**TOWN OF MOUNTAIN VILLAGE  
REGULAR DESIGN REVIEW BOARD MEETING  
THURSDAY DECEMBER 5, 2019 10:00 AM  
2nd FLOOR CONFERENCE ROOM, MOUNTAIN VILLAGE TOWN HALL  
455 MOUNTAIN VILLAGE BLVD, MOUNTAIN VILLAGE, COLORADO  
AGENDA**

**Agenda Item No. 6  
PLANNING AND DEVELOPMENT SERVICES  
DEPARTMENT**

**Case Summary:** Chris Hawkins of Alpine Planning and Tommy Hein of Tommy Hein Architects, acting on behalf of O’Dea Development Services, INC., are requesting Design Review Board (DRB) Initial Architectural and Site Review approval of a new single-family home located at 102 Granite Ridge, Lot 137. The applicants have submitted all required materials in accordance with the provisions of Section 17.4.6 of the Community Development Code (CDC) for a Class 3 Initial Review.

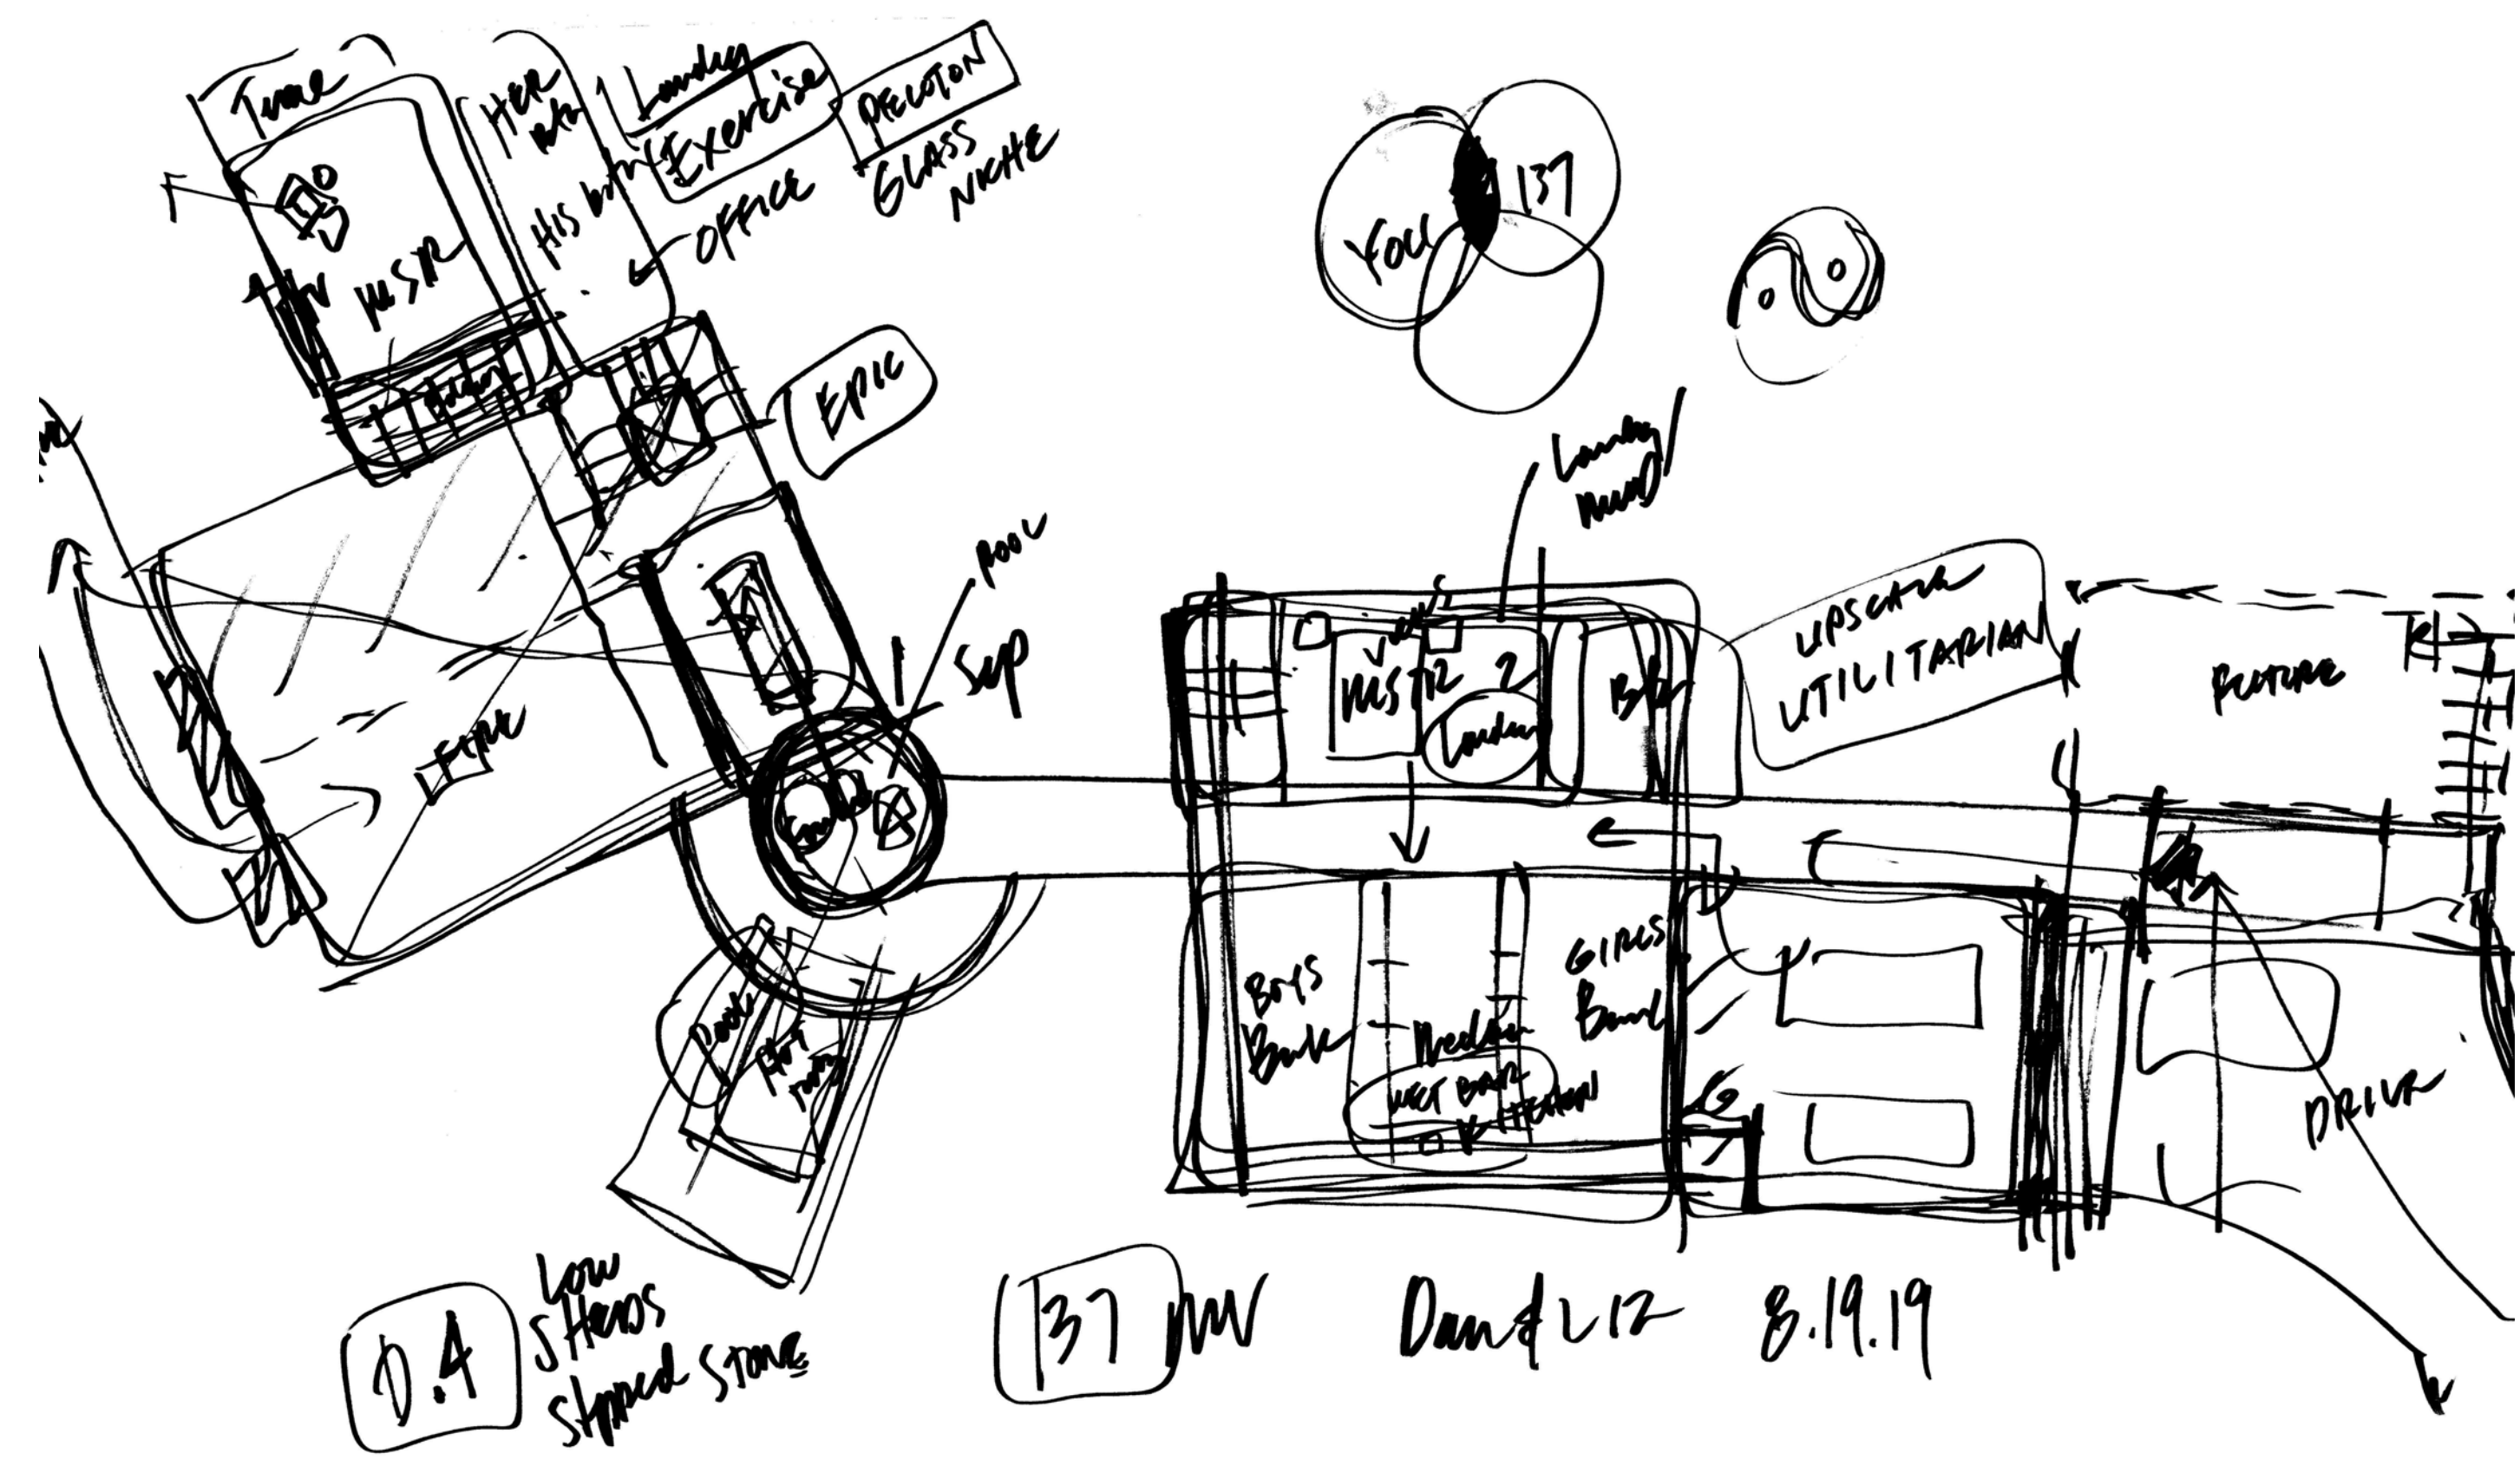
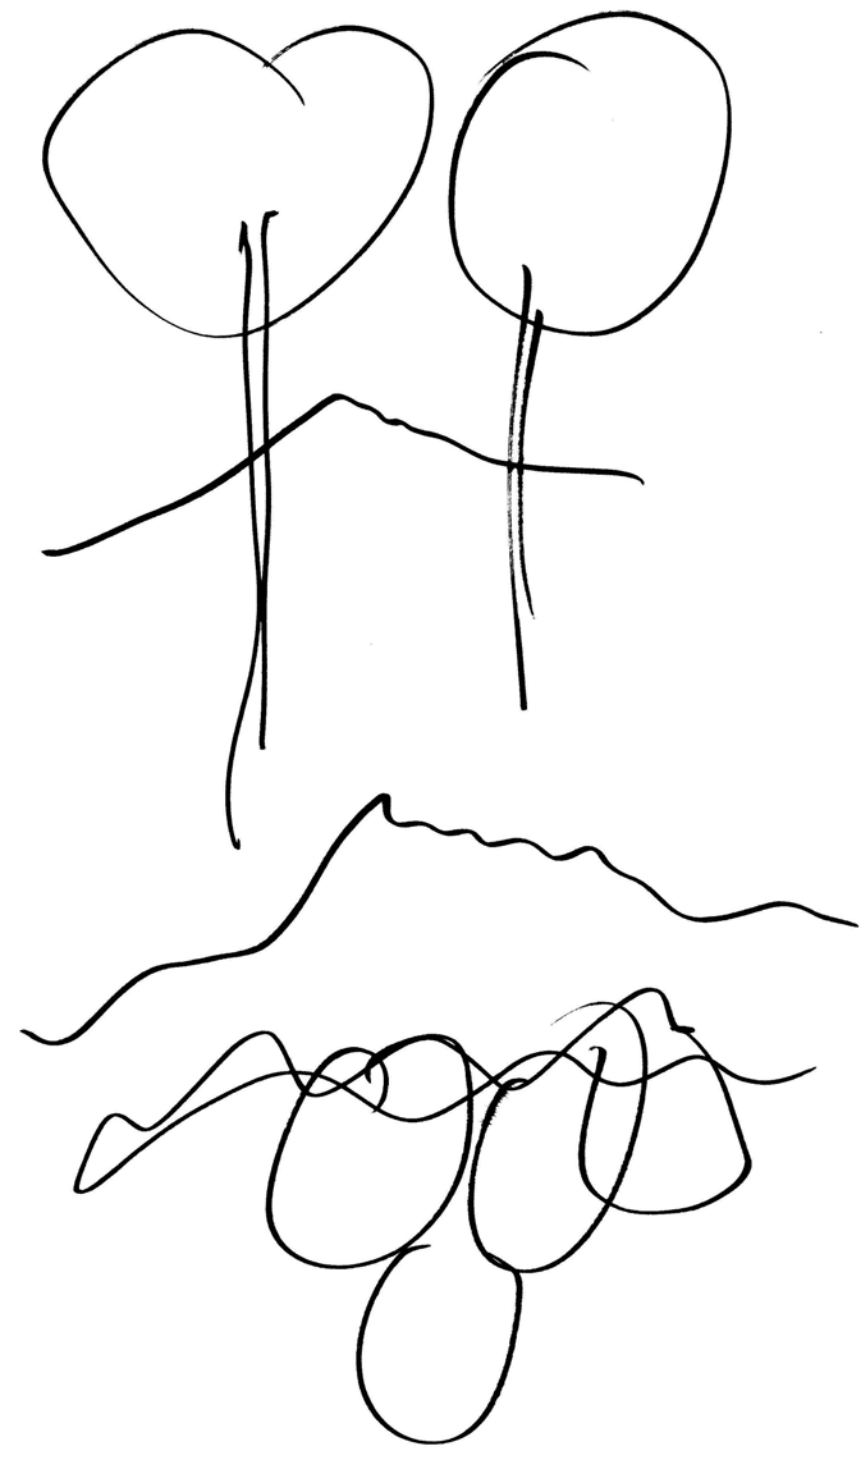
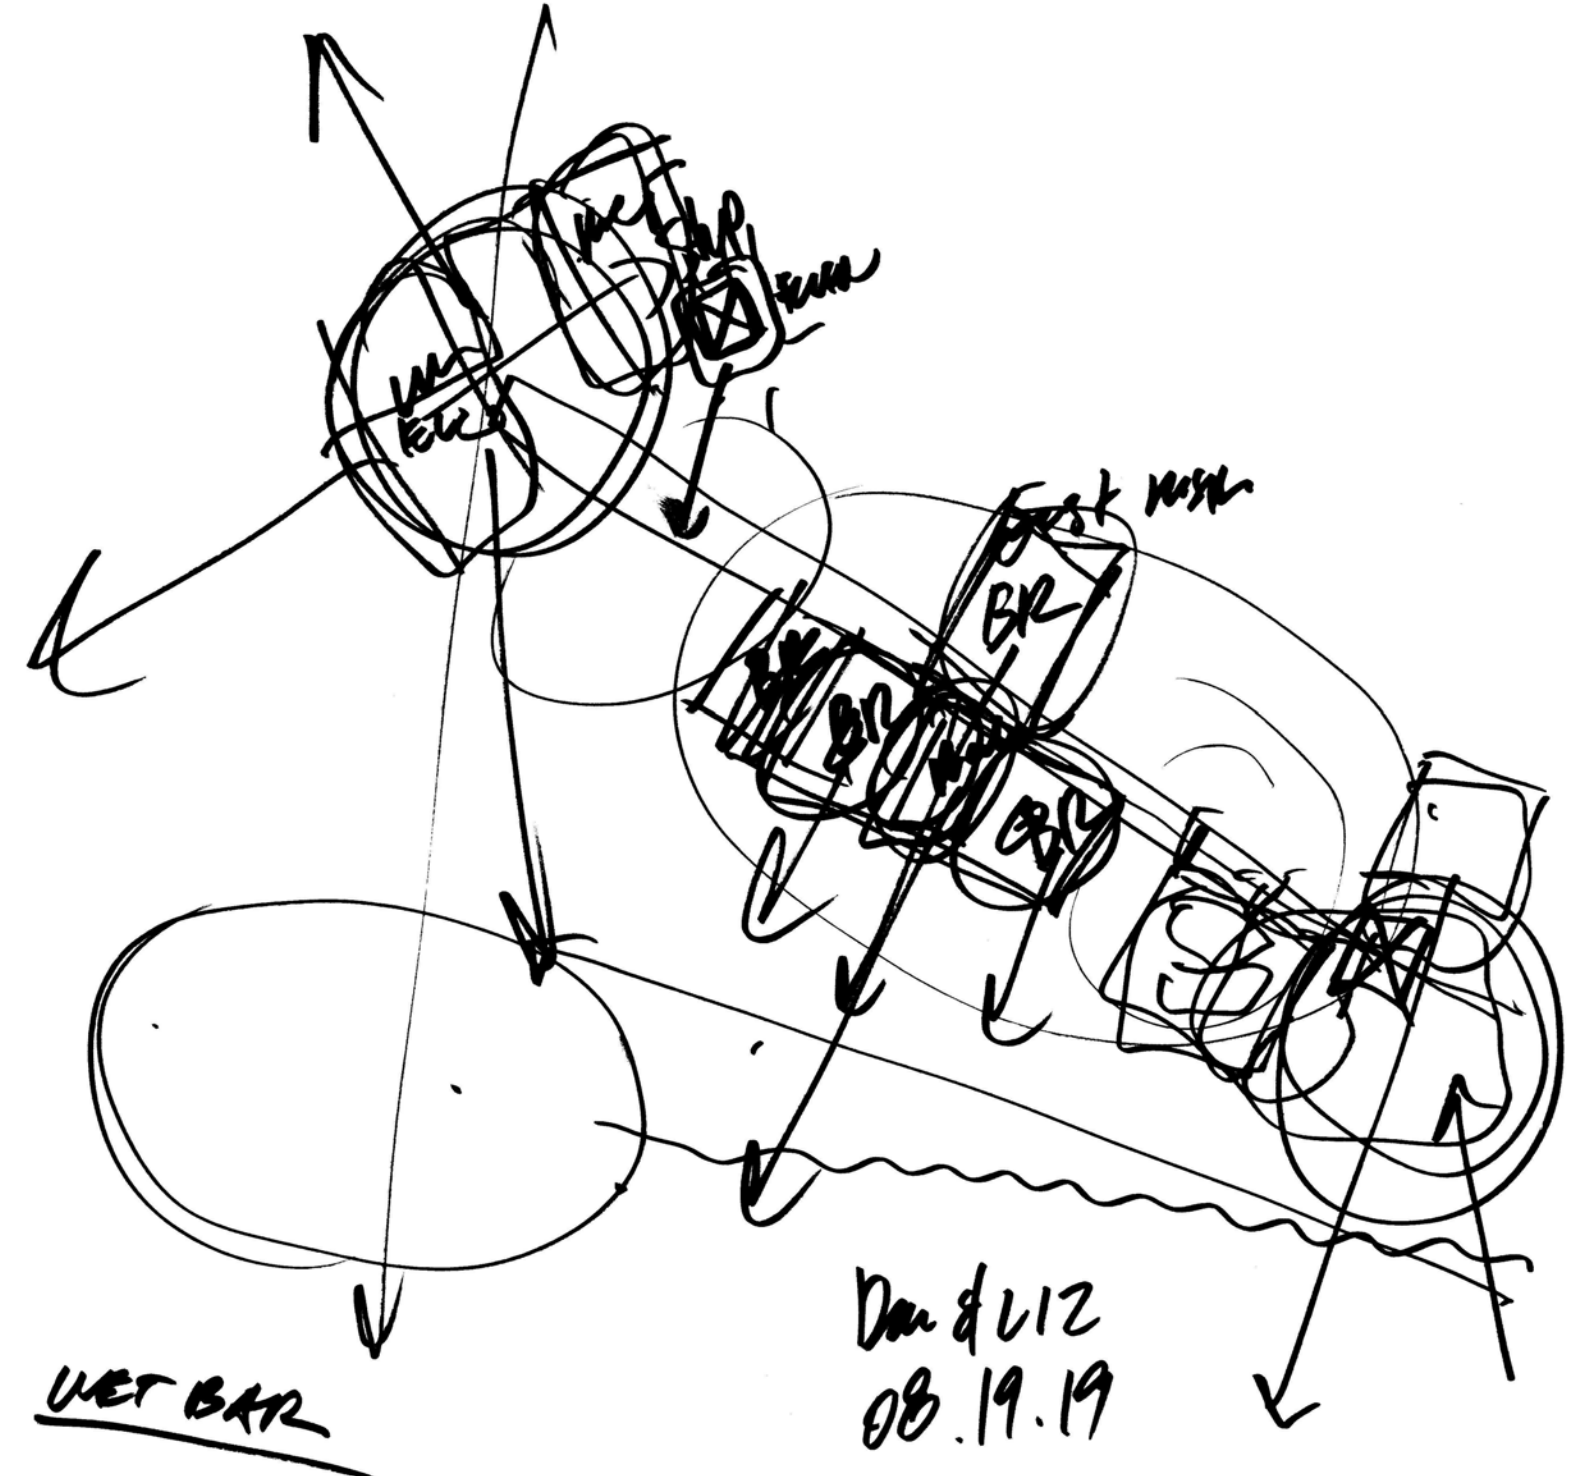
*Ski Access: Sheet A1.0 of the submitted plans show a ski in – ski out access that is generally located within the driveway area. It's unclear to staff at this time as to how the applicants propose to traverse from Lot 137 to the ski resort as there are no contiguous parcels owned by TSG between the lot and the resort. If this is determined to be unrealistic, then the applicants will need to revise plans and remove references to ski access prior to final review. Otherwise, the applicants will need to provide written documentation from TSG permitting access from the site to the resort.*
